POLICY REPORT  
DEVELOPMENT AND BUILDING

TO: Vancouver City Council  
FROM: General Manager of Planning and Development Services  
SUBJECT: CD-1 Rezoning: 5508-5542 Oak Street

5508-5542 Oak Street  
FORM OF DEVELOPMENT

Site/Landscape Plan

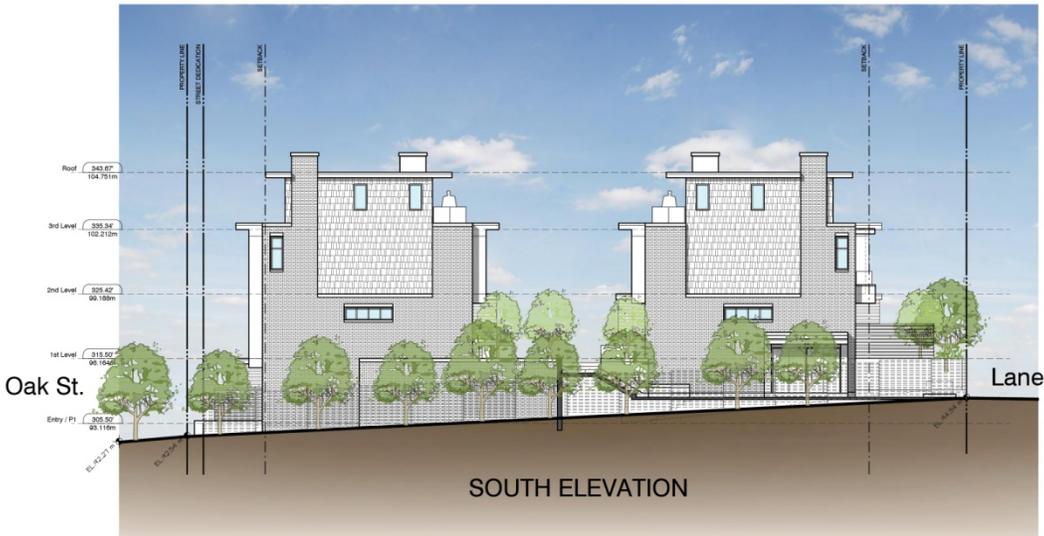
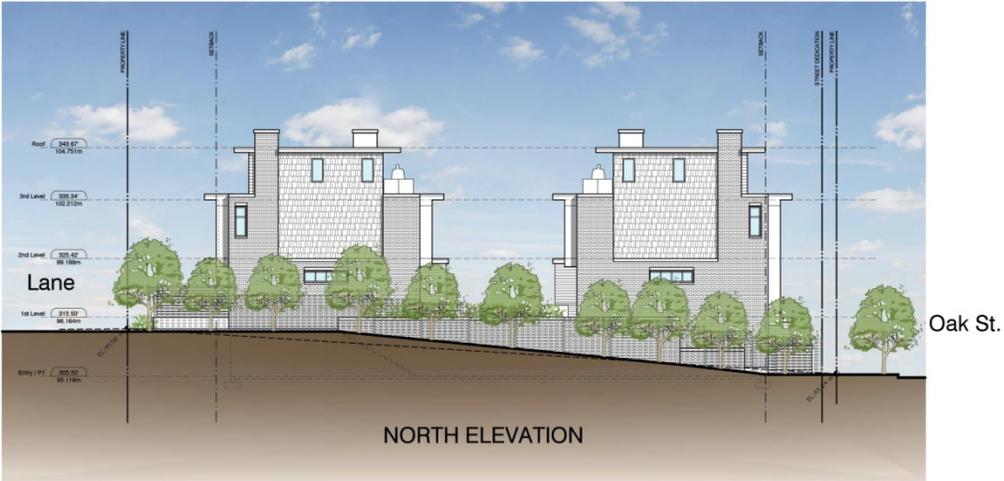
- 1. Design development to provide further variation in the roof form and architectural detailing to provide visual relief, particularly at the rear building.

- 2. Design development to provide a clearer distinction between the public and private realm at the front entries along Oak Street.

- 3. Design development to provide improved animation and articulation of the lane edge by providing entries to the patios at the rear units.

4. Design development to the semi-private courtyard to provide improved opportunities for social interaction and informal children's play.

8. Site utilities and vents located onto private property and integrated discreetly into the building, avoiding landscaped and common areas.

11. Provision of a detailed Landscape Plan illustrating common and botanical name, size and quantity of all existing/ proposed plant material.

- Design development to improve the colour palette;
- Consider opening the mid-block connection through to the lane;
- Design development to reduce the repetitiveness of the lane expression;
- Design development to improve the roof expression;
- Consider a gathering space in the courtyard;
- Design development to improve the mid-block stair.

The Panel thought the stepped form was a better fit for the neighbourhood but thought the colour palette was too dark and wanted to see more contrast. As well they thought the mid-block connection was appropriate for the site but wanted to see if go through to the lane. Most of the Panel members thought the expression on the lane was too repetitive and suggested having a change in colour or other some other element. As well they suggested breaking up the roof elements to help articulate the townhouses differently. One Panel member suggested a canted or peaked roof.

The Panel supported the landscaping plans but wanted to see some opportunities for seating in the courtyard. As well they thought the access points could be improved especially the mid-block stair.

Note to Applicant: This may be achieved by varying the roof height, introducing a distinct roof form and/or providing clerestory glazing and material/color changes to further distinguish the proposed central element at the rear building. Overall height to 43 ft. is supported to facilitate design development in this regard.

Note to Applicant: This may be achieved by providing an elevated main floor and entry and/or a more robust fence detail. The fence should not be entirely solid, but should incorporate transparent panels to provide views through and contribute to pedestrian visual interest. Fence height at the front yard is limited to 4 feet.

Note to Applicant: The rear patio walls should be further articulated to add visual interest and a sense of scale. At-grade landscaping and planters should continue to be incorporated into the wall design. A section and elevation detail

Note to Applicant: This may be achieved by creating areas of special interest and focus along common pathways as part of the overall landscape design.

Note to Applicant: Every effort should be made to screen pad-mount transformers that are open to the lane with lockable gates (Further coordination with BC Hydro is required).

Note to Applicant: Plant material should be clearly illustrated on the Landscape Plan and keyed to the Plant List. The landscape plan should include all exterior hard and soft surface elements (site furniture, gates, fences, surfaces, screens, walls), the public realm treatment (to the curb) and all existing or proposed street trees, adjoining landscaping/grades and public utilities such as lamp posts, hydro poles, fire hydrants.
